TECHNICAL SERVICE BULLETIN

Number: TSB-COM-VAC-2015-002

Symptom: Wheel spare part kit for VU500

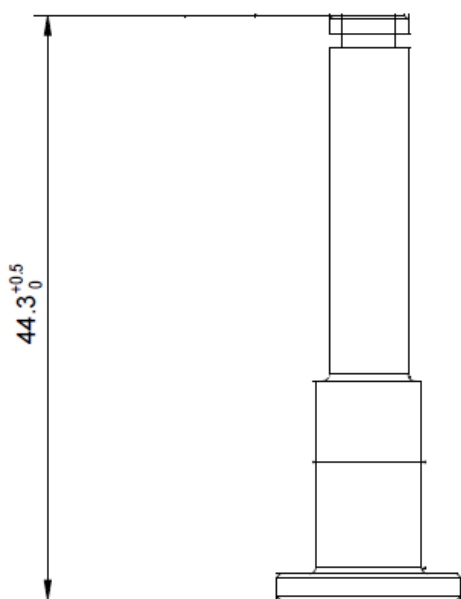
The wheel shaft in spare part 147 0898 500 is too short for the VU500.

Spare part lists was referring to the wheel shaft kit for GU 305/355/455 and Spectrum upright vacuum cleaners. The shaft in these kits are shorter then the one used in VU500.

Correct for VU500:

Wrong for VU500:

New shaft wheel kit 107416451 has been created including a longer shaft that fits VU500.

Locally made and distributed spare part list must be updated.

107416451 WHEEL SHAFT KIT
